To: T10 Technical Committee
From: Rob Elliott, HP (elliott@hp.com)
Date: 24 December 2004
Subject: 04-340r1 SAS-1.1 OPEN_REJECT BAD DESTINATION handling

Revision 1 (24 December 2004) Incorporated changes based on November SAS protocol WG meeting - recommend that expanders to send NO DESTINATION instead of requiring that end devices treat BAD DESTINATION as retry-class.

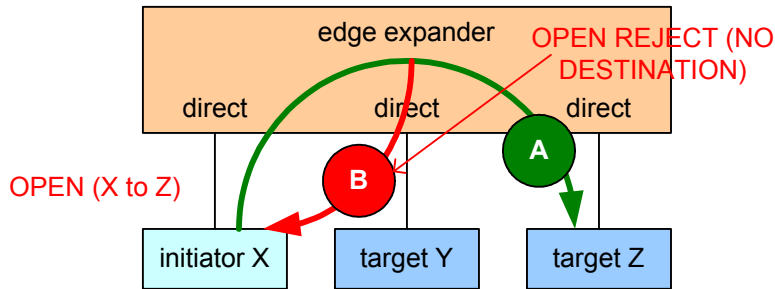
When the physical link to a destination SAS address goes down, the response can be either OPEN_REJECT (NO DESTINATION) or OPEN_REJECT (BAD DESTINATION) depending on whether there is a subtractive port in one of the expanders (see figure).

OPEN_REJECT (NO DESTINATION) is in the retry class of responses, meaning the OPEN will be attempted again until the I_T nexus loss timer expires. OPEN_REJECT (BAD DESTINATION) is in the abandon class, meaning the OPEN is not reattempted.

Since the physical link might become enabled again, the retry behavior is appropriate.

- a) Require that expanders return NO DESTINATION instead of BAD DESTINATION for phys using either the subtractive or table routing methods (not just subtractive as currently defined). Phys using the direct method (i.e. attached to an end device) would still return BAD DESTINATION. This means the request must have arrived through a subtractive phy in an attached expander; or
- b) Treat BAD DESTINATION as a retry-class response rather than an abandon-class response.

This revision proposes option a). Since this is handled in hardware by all existing expanders, it is only proposed as a "should".

With no subtractive port:

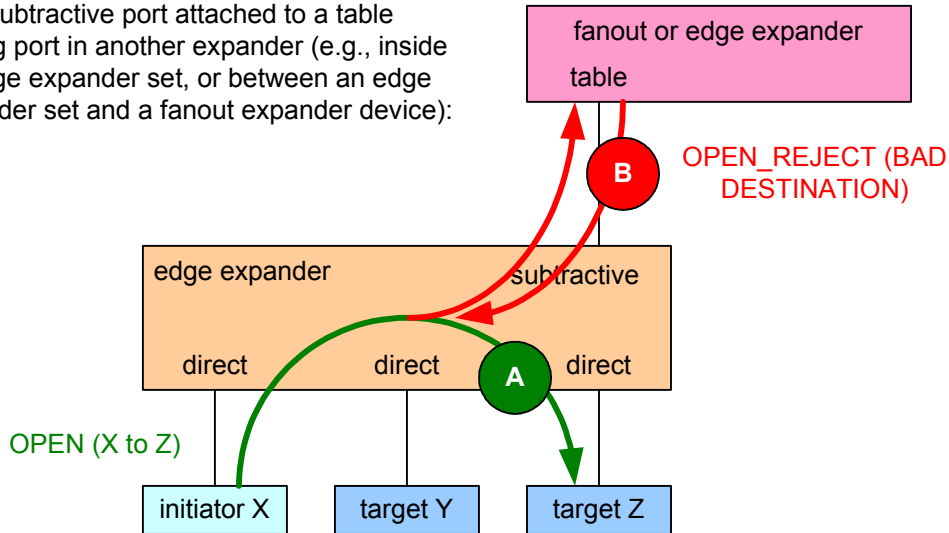
- A) before target physical link goes offline, OPEN routed to target
- B) after target physical link goes offline. OPEN_REJECT (NO DESTINATION) from edge expander

With subtractive port attached to a table routing port in another expander (e.g., inside an edge expander set, or between an edge expander set and a fanout expander device):

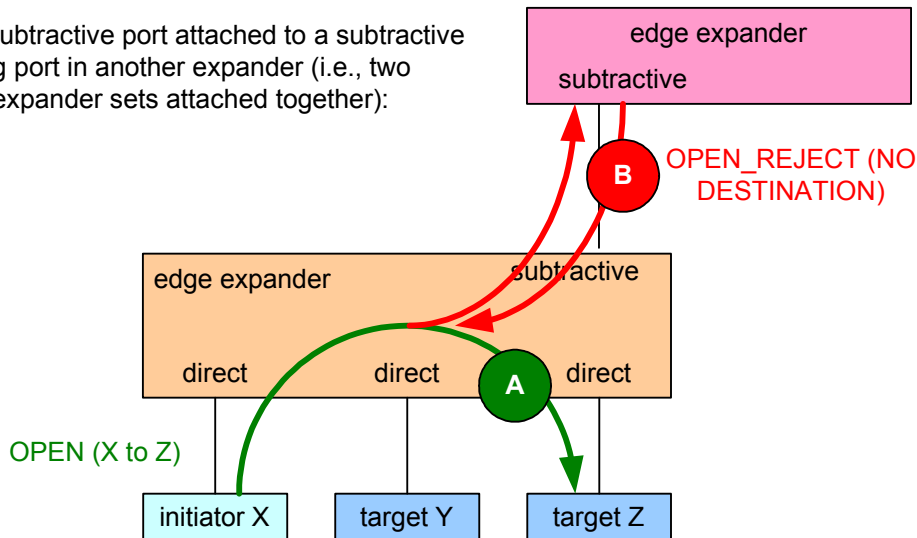
- A) before target physical link goes offline, OPENs routed to target
- B) after target physical link goes offline, OPEN_REJECT (BAD DESTINATION) from top expander
